# Lauprete Residence

Conservation Commission Presentation  
FEBRUARY 23, 2021

# NEW REVISED PLAN 2/23

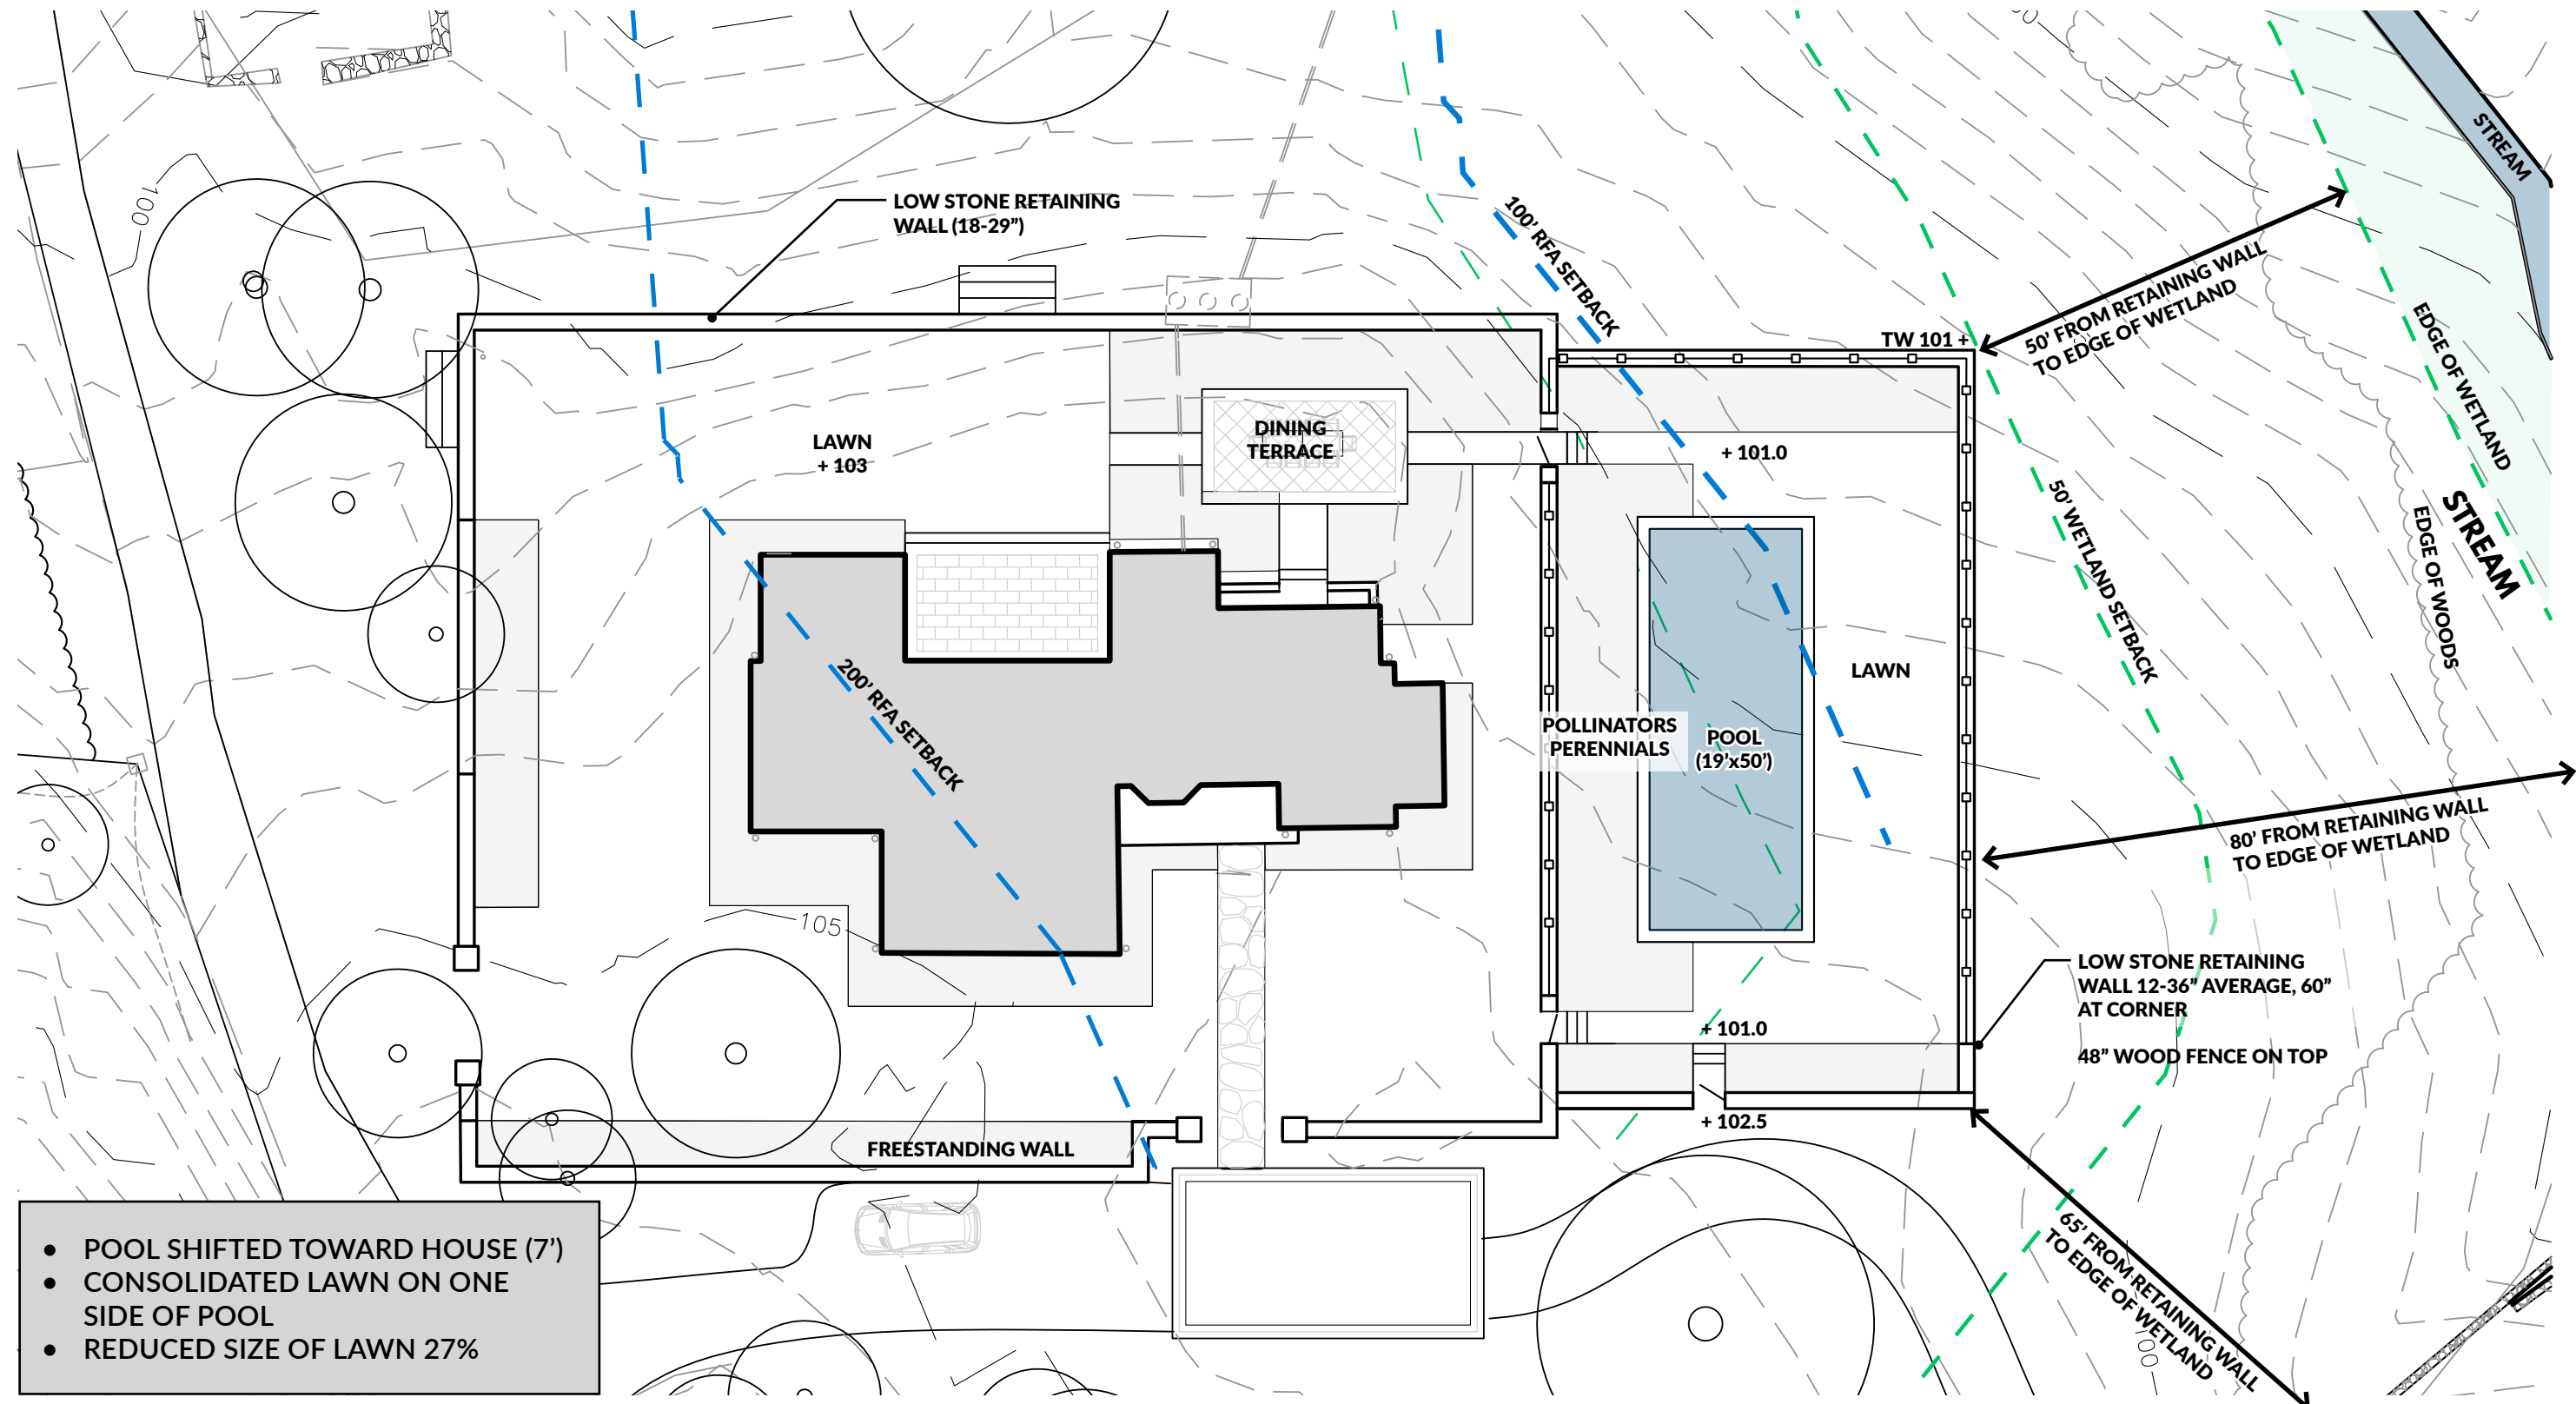
- POOL SHIFTED TOWARD HOUSE (7')
- CONSOLIDATED LAWN ON ONE SIDE OF POOL
- REDUCED SIZE OF LAWN 27%

# PREVIOUS DESIGN COMPARED TO CURRENT PROPOSAL

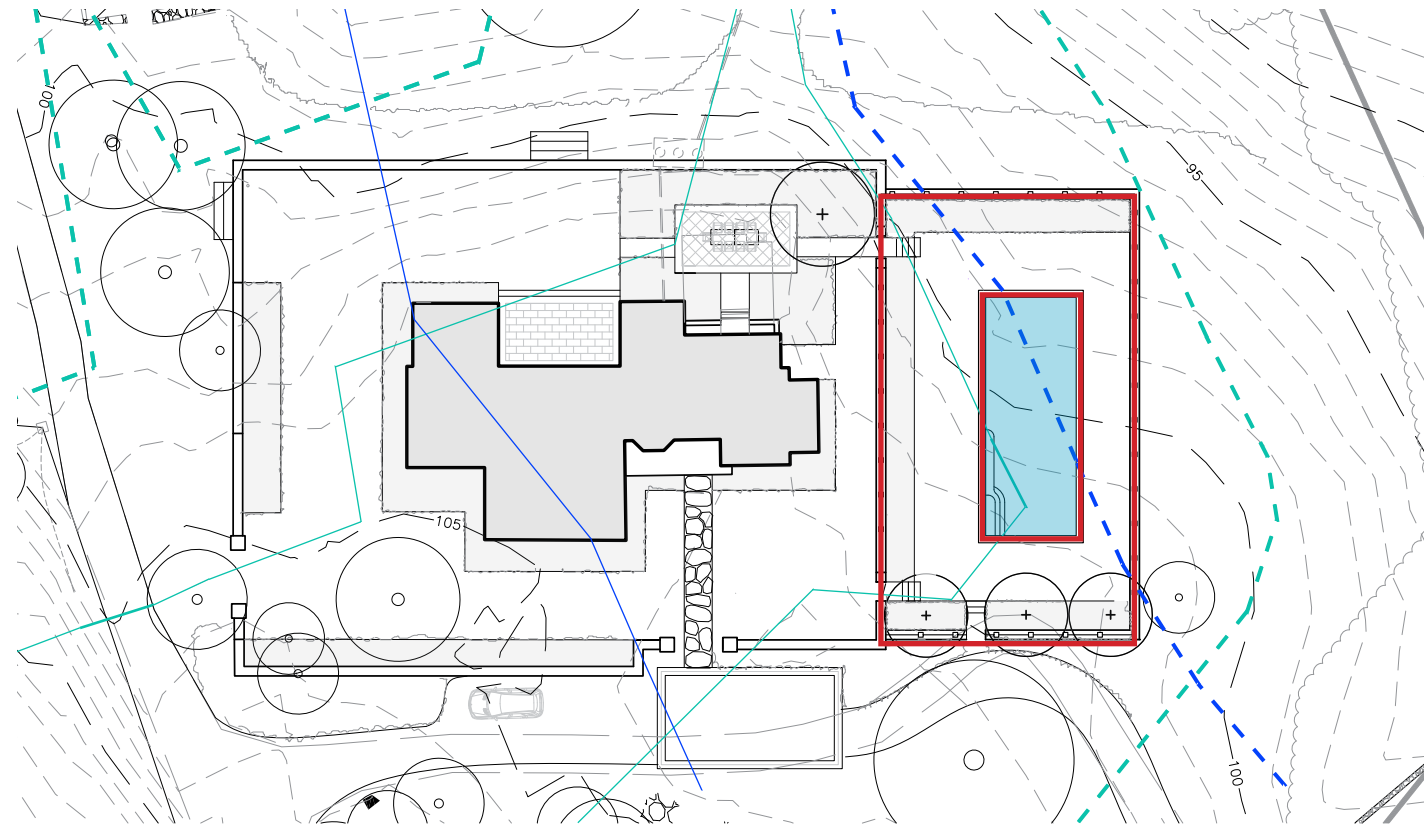
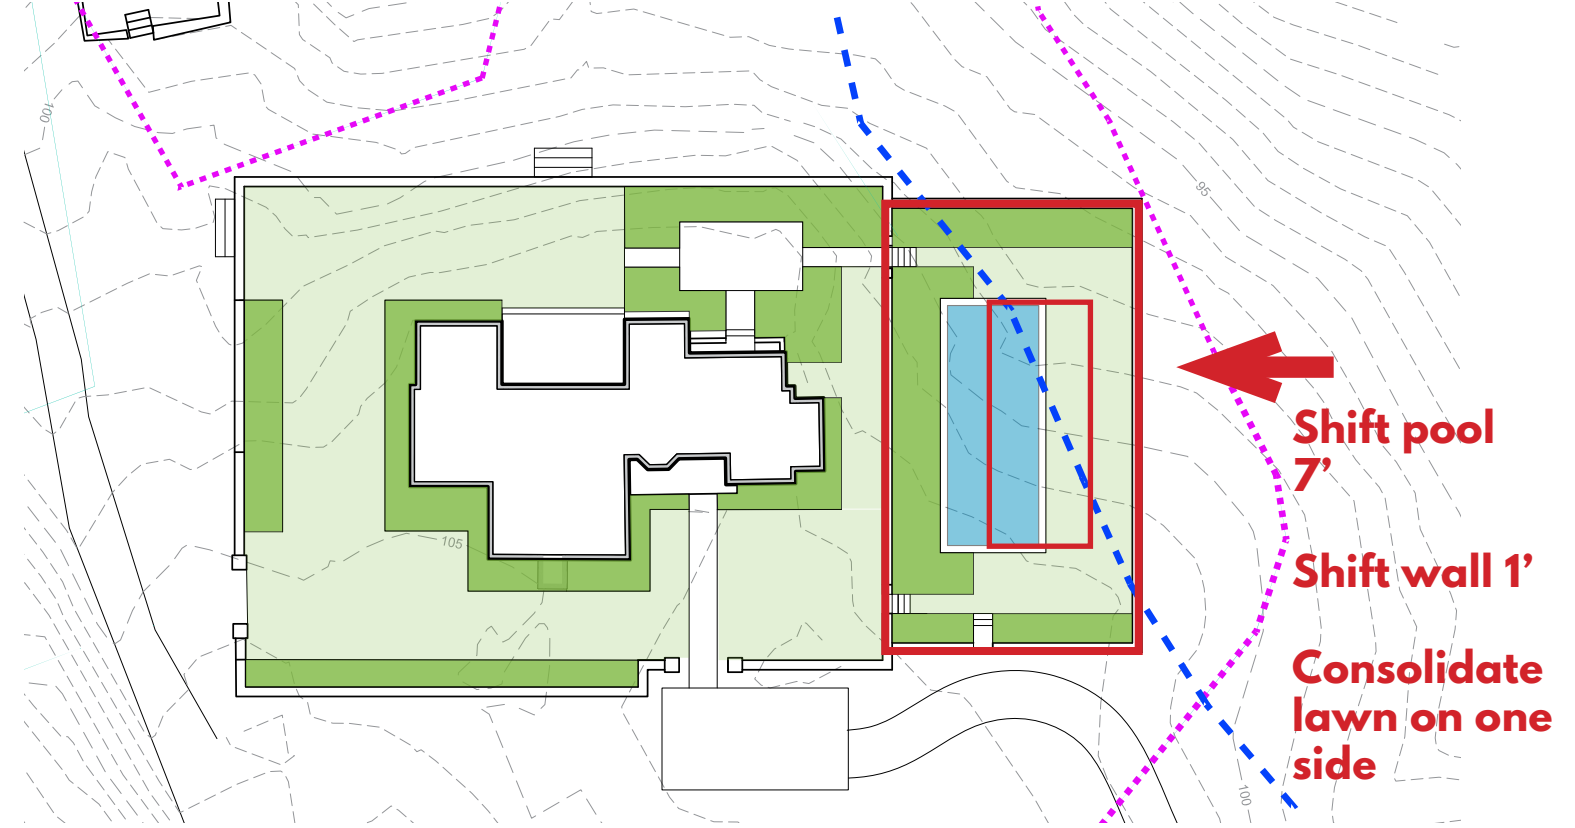
PREVIOUS DESIGN 2/9/21

CURRENT DESIGN PROPOSAL

# PREVIOUS DESIGN COMPARED TO CURRENT PROPOSAL

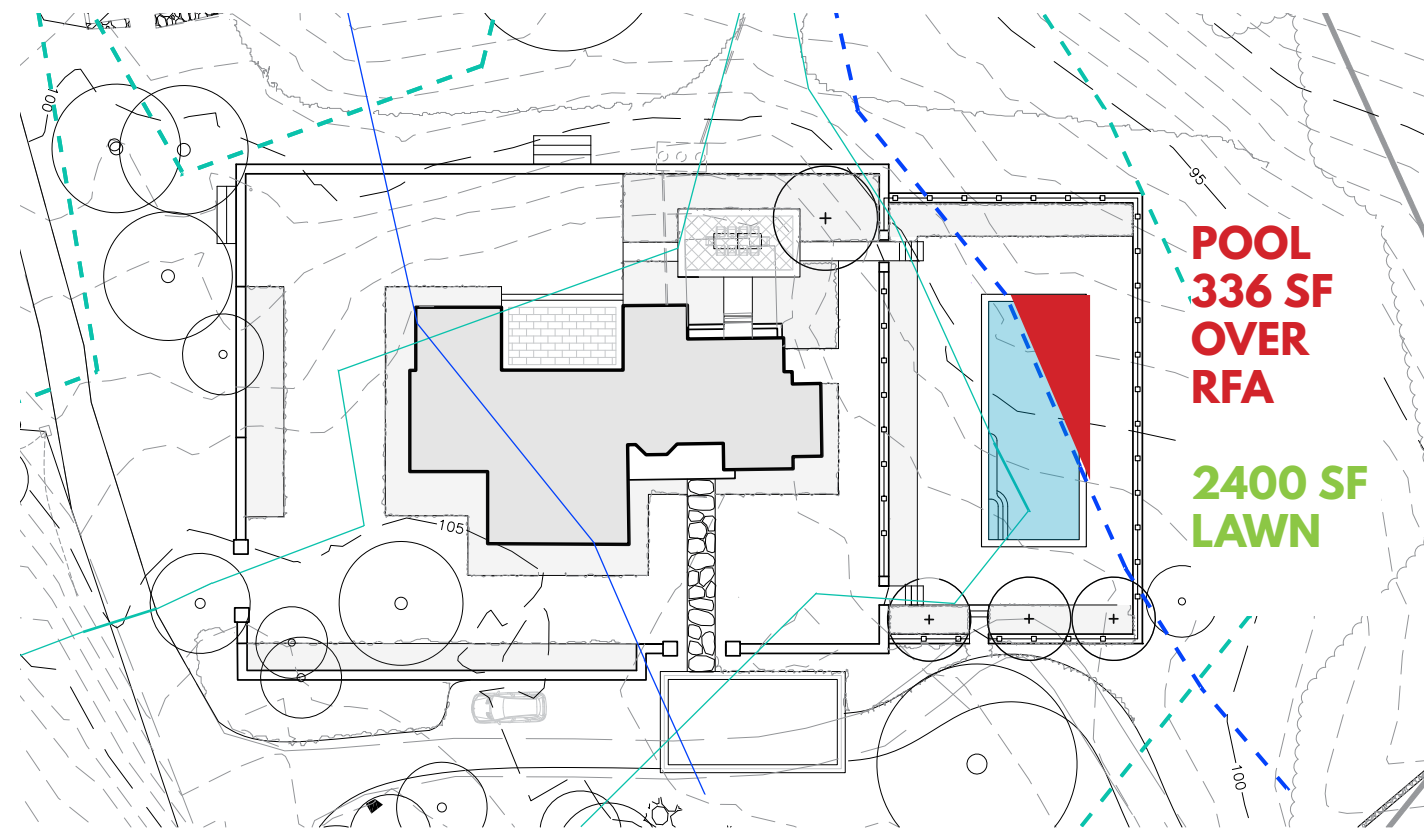
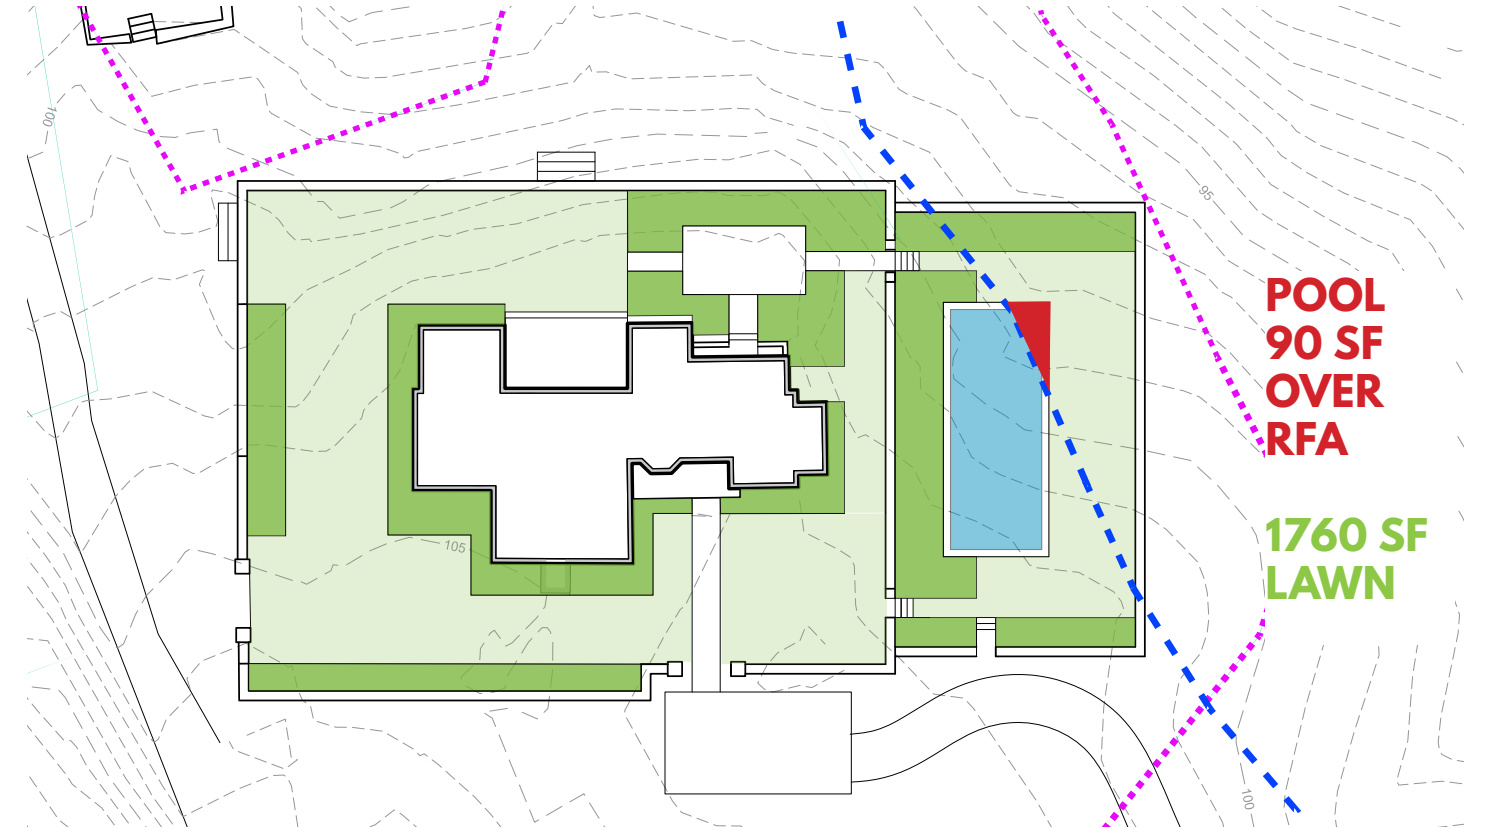
**370% REDUCTION OF POOL  
AREA OVERLAPPING RFA**

**27% REDUCTION LAWN**

# WHY WE CAN'T SHIFT THE POOL 100% OUT OF RFA: DOESN'T WORK SPATIALLY

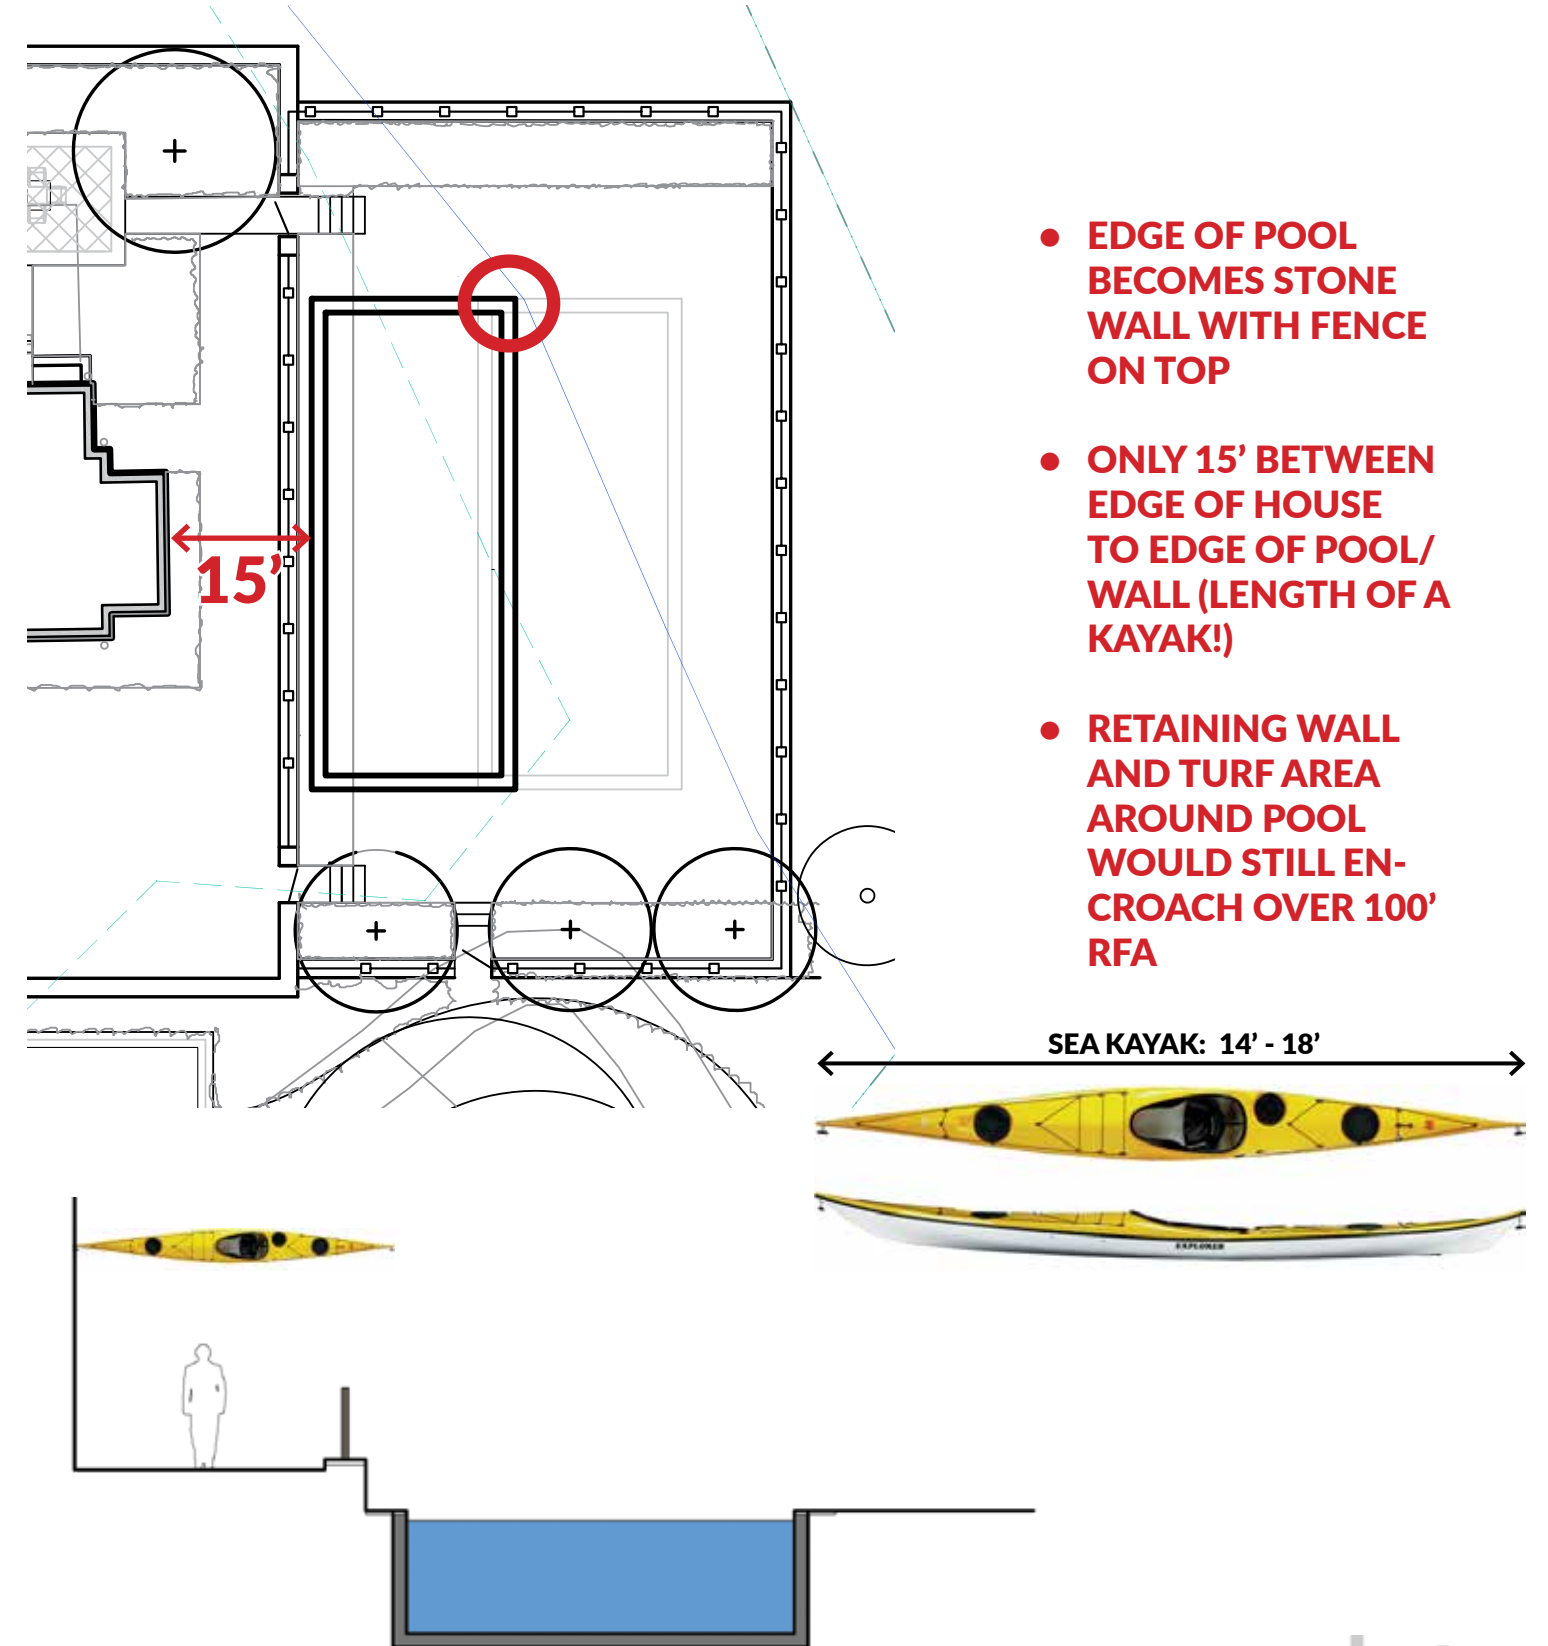
SHIFTING POOL TOWARDS HOUSE UNTIL IT CLEARS THE 100' RFA
